Staff Analysis

- Agenda Item: **4.B**
- Proposal: **Application for preliminary site plan approval for the Lake Point Lodge - an apartment building, club house and associated improvements on 5.02 acres, more or less.**

- Case No: PZ15-03
- Applicant: KGH Building Group LLC
- Owners: SKG, LLC
- Parcel # (s): 20-7.0-26-100-003-012.001, 20-7.0-26-100-003-012.002 and 20-7.0-26-100-003-013.000.

SITE PLAN

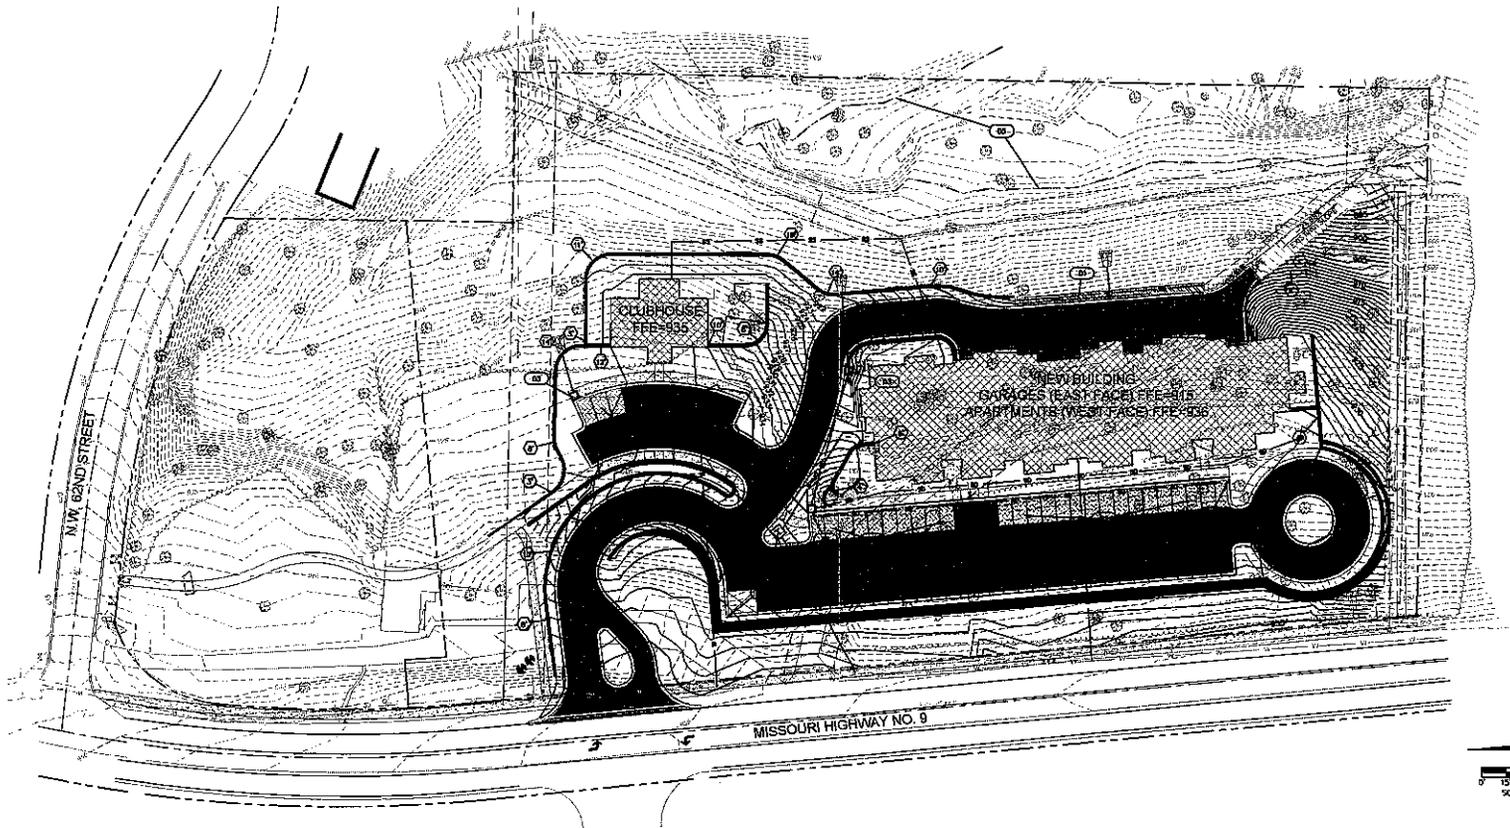
- moving the west parking lot approximately 10 feet closer to the building, addressing fire access comments and providing increase separation from 9 Highway – increasing the average setback between the western retaining wall and the 9 Highway right-of-way to 29 feet with 45 feet to the edge of pavement (the closest point would be the retaining wall around the cul-de-sac bulb at 15 feet from the right-of-way and 31 feet from the edge of pavement);
- terracing the retaining wall to create two tiers with landscaped planting beds between;
- the addition of rolled back or mountable curbs and a paved apron to accommodate 30-foot trucks in the cul-de-sac; and
- submittal of photometric plans and lighting details.

7. **Retaining walls and guard rails** – The preliminary site plans have been modified to revise the western most retaining wall. The wall is approximately 13 feet tall and has been modified to include two tiers with a landscaping bed between the two wall sections. A 3' 6" guard rail is also shown along the top of the fence. A note has been added to clarify that the rail will look similar to black aluminum railing proposed for the balconies. Landscaping is also proposed along the back side of the proposed sidewalk along 9 Highway. The vegetation is intended to improve the appearance along the 9 Highway frontage but would also help create an additional buffer between vehicular traffic on 9 Highway and the 13 foot drop to the west parking lot.

8. **Fire safety** – The application has been reviewed by the Southern Platte Fire Protection District (SPFPD) staff. SPFPD has identified the need to access the site with their largest vehicle, a 40-foot ladder truck. The plans were revised to verify the 40 foot ladder truck can be circulated within the site as required by the adopted Fire Code.

SPFPD has previously recommended that all roads and driveways providing access to the fire department be widened to 26 feet minimum, that roll-back or mountable curbs be used and that the separation between the building and the front parking lot not exceed 30 feet to allow adequate access with ladders and that the separation be no less than 15 feet for fire safety. The plans were revised to move the west parking lot closer to the building to meet the 30 foot maximum separation, rollback or mountable curbs are called out and an apron

has been added behind the curb in the cul-de-sac to allow greater turning radius and accommodate over steering.

9. **Drive slopes** – The revised plans verify that all drive slopes are less than the City's maximum allowable slope of 15%. Proposed slopes range from slightly less than 6% to nearly 14%. Moving the west parking lot closer to the building did not change the drive slopes within the site. It did however reduce the slope on the area between the sidewalk and westernmost retaining wall.

1 SITE PHOTOMETRICS PLAN
SCALE: 1" = 30'

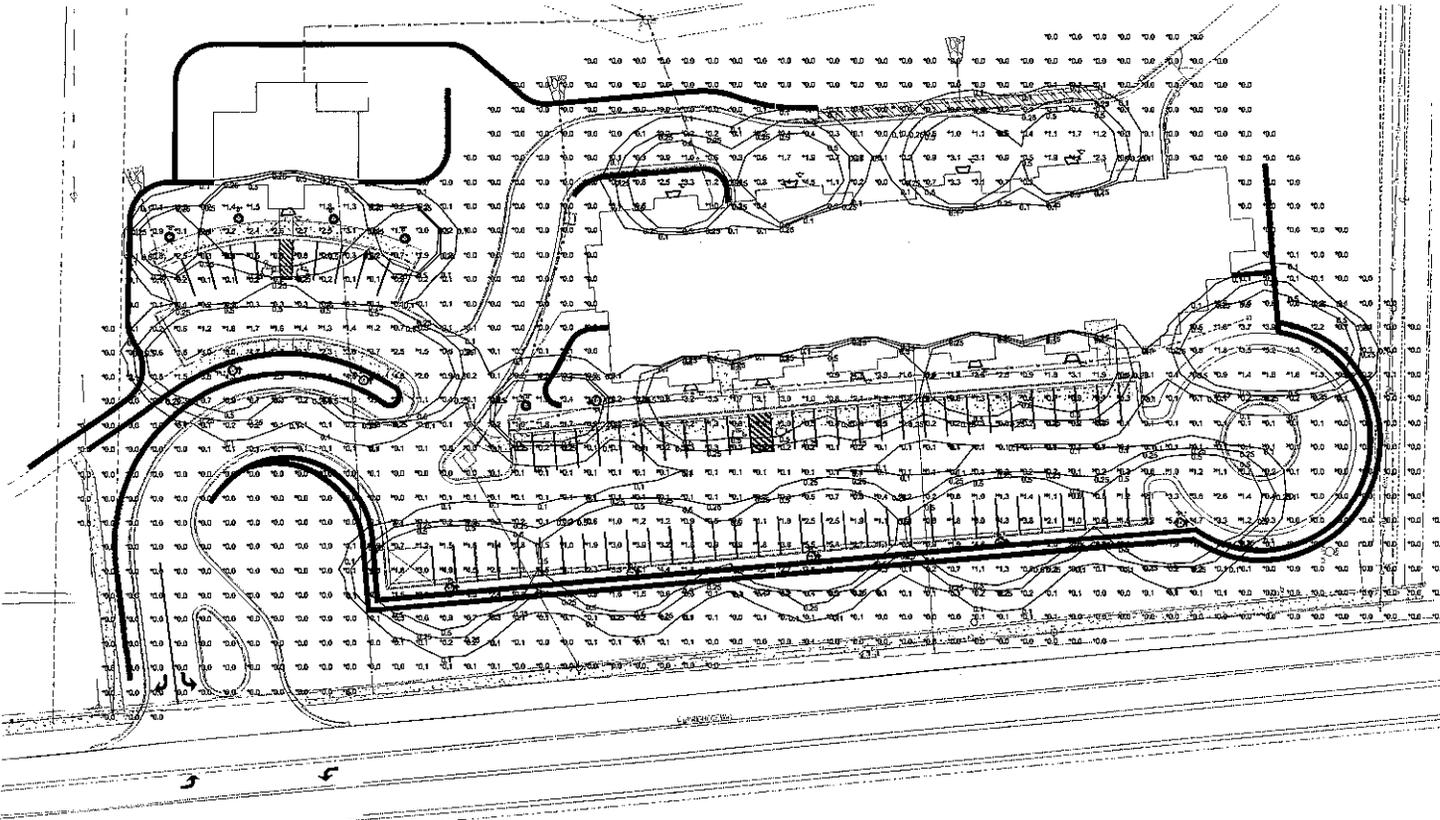
4. **Exterior lighting** – An exterior lighting plan has been submitted with the revised plans (see sheets E1.0 and E2.0). The plans show pole lights, bollard lights and building mounted exterior lights. The pole lights have recessed lenses to minimize glare and light spillover onto abutting properties. The plans show that the lighting does not spillover onto abutting properties or the public right-of-way (0.0 foot candles at the property lines). Plan approval should be subject to final lighting plan approval and inclusion of all final exterior building lighting. This is particularly important as it relates to glare for traffic on 9 Highway and light spillover on to the abutting residential properties.
